**ZONING CHANGE REVIEW SHEET**

**CASE:** C814-2014-0120 – Austin Oaks Planned Unit Development

**ADDRESS:** Southwest Corner of Mo-Pac and Spicewood Springs Road (3409, 3420, 3429, 3445, 3520, 3636, 3701, 3721, 3724, and 3737 Executive Center Drive and 7601, 7718 and 7719 Wood Hollow Drive)

EXHIBIT C  
 AUGUST 30, 2016  
 UDG JOB NO. 15-864  
 1"=100'  
 CASE NUMBER: C814-2014-0120

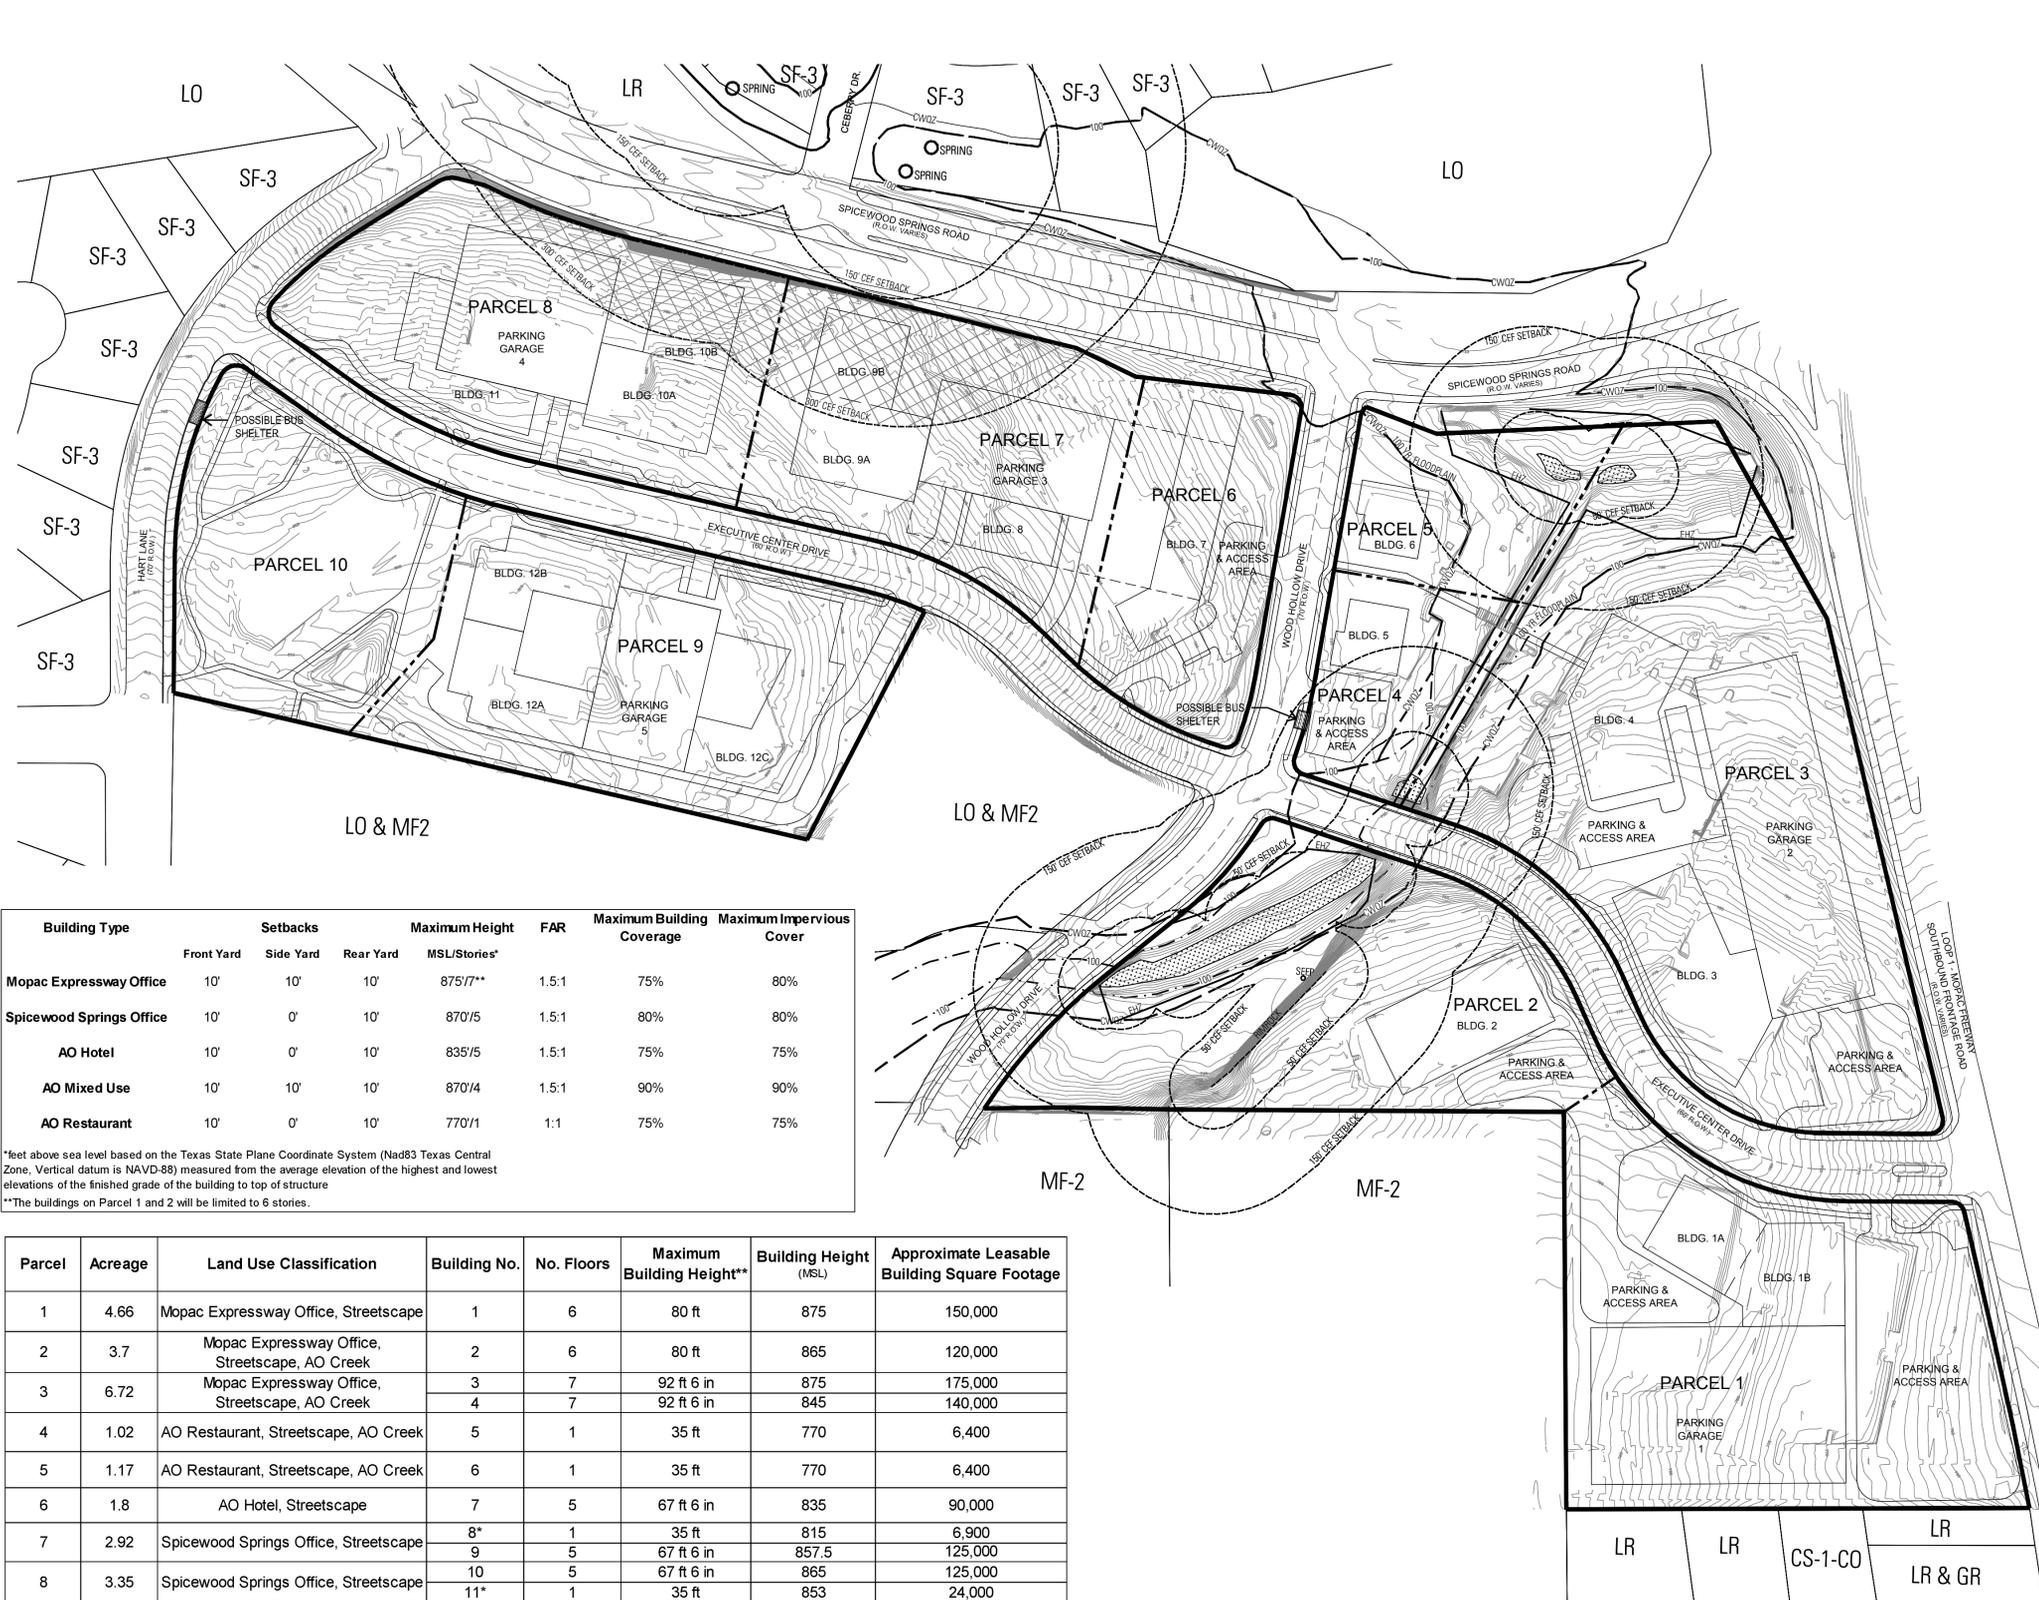
EO 15. The CWQZ, 100-year floodplain, and CEF buffers are difficult to read on this plan. Please revise the symbology to better illustrate the environmental features on the land use plan. Can the Erosion Hazard Zone and Drainage Easements be removed to make the plan easier to read?

Update 4: Under 25-8-92(F), the boundaries of a CWQZ in an urban watershed coincide with the boundaries of the 100-year fully developed floodplain, with a minimum width of 50' and a maximum width of 400'. There are several places where the 100-year fully developed floodplain extends beyond the identified CWQZ. Please correct the CWQZ boundaries to follow the 100-year fully developed floodplain in areas where the floodplain width is between 50' and 400' from the creek centerline. (Maintain a minimum CWQZ width of 50' where the floodplain is narrower than 50' from centerline.)
